SERIES 60[®] EGR Technician's Guide

NUMBER: 08 60 EGR-1 **S.M. REF.:** See Table **ENGINE:** EPA04 Series 60 EGR **DATE:** November 2008

SUBJECT: EGR VALVE DIAGNOSTICS

PUBLICATION: DDC-SVC-MAN-0078

Figure 1 Gage Setup

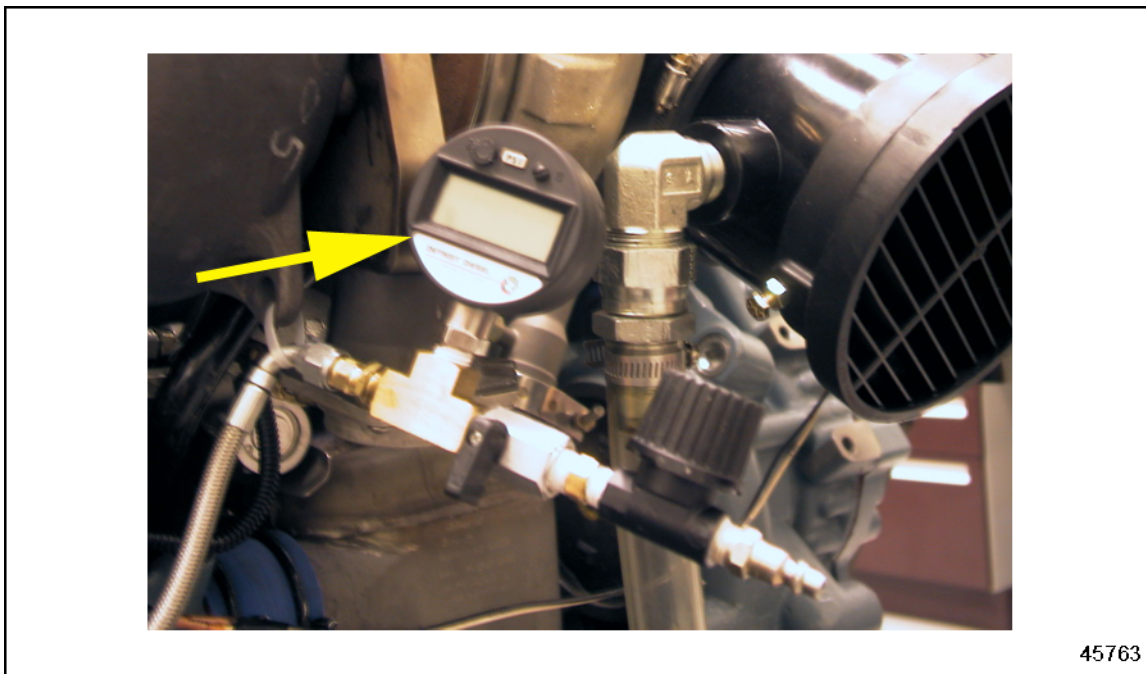
Section	Change
10.4.1 Test A, refer to section 10.4.1	Test A has been revised with a new procedure.
10.4.3.1 Delta P Sensor Test, refer to Section 10.4.3.1	Delta P Sensor Test steps 1 through 4 have been updated.
10.4.3.2 VPOD Output Pressure Test, refer to section 10.4.3.2	VPOD Output Pressure Test step 3 has been changed from 305 kPa to 483–517 kPa (70–75 psi @ VPOD)
10.4.4 Test D, refer to section 10.4.4	Test D has been revised with a new procedure.

1. Disconnect the air hose from the VNT actuator.
2. Install gauge at the outlet of the VNT air line. See Figure 1.

3. Using either DDDL or DDR, activate the PWM #4 duty cycles and monitor the output pressure from the VPOD. Activate the duty cycle to 90%. Pressure should equal 483-517 kPa (70-75 psi @ VPOD).
